Meeting Notice and Agenda Hillside Building Committee

Wednesday, June 8, 2022 8:00 AM Town Hall Boardroom

A. 22-238 Formal review for a new single family residence at 4517 E Desert

B. <u>22-239</u> Combined review of a natural-looking path and sitting area with

4211 E. Claremont Project Update

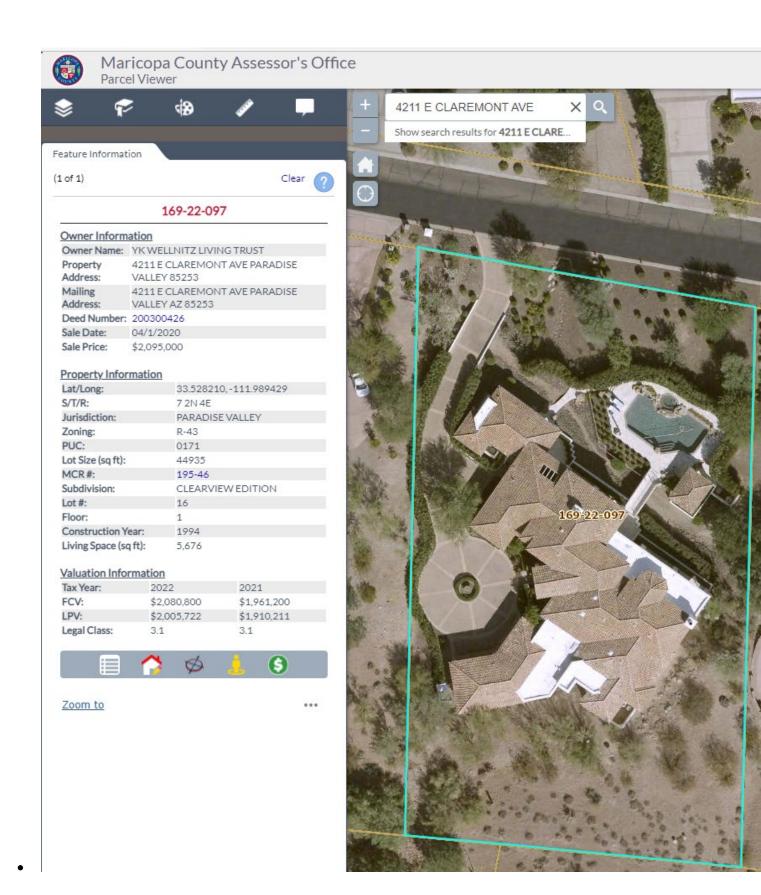
Based upon feedback from the May 11, 2022 meeting with the Paradise Valley Hillside Building Committee we propose the following updates to our original plan:

- 1) Treat the DC Cobble rocks to darken their color.
 - a. Permeon is another mentioned product. Reached Eric Tyler and Tyler Mefferd to obtain additional product information.

- 2) Remove all 13 vegetation lights from the visible portion of the path. Only 5 path lights will remain on the portion of the path visible from neighbors. Note, the path adjacent the east side of the home is below the elevation of the home and the soil.

- 3) Rake the entire disturbed area to integrate the rock and soil for a more natural look.
- 4) Replace the planned vegetation with a native seed mix. Currently seeking a "Desert Mountain Seed Mix" or "Sonoran Desert Shrub Seed Mix" from Native Seeds and Cactus Store.
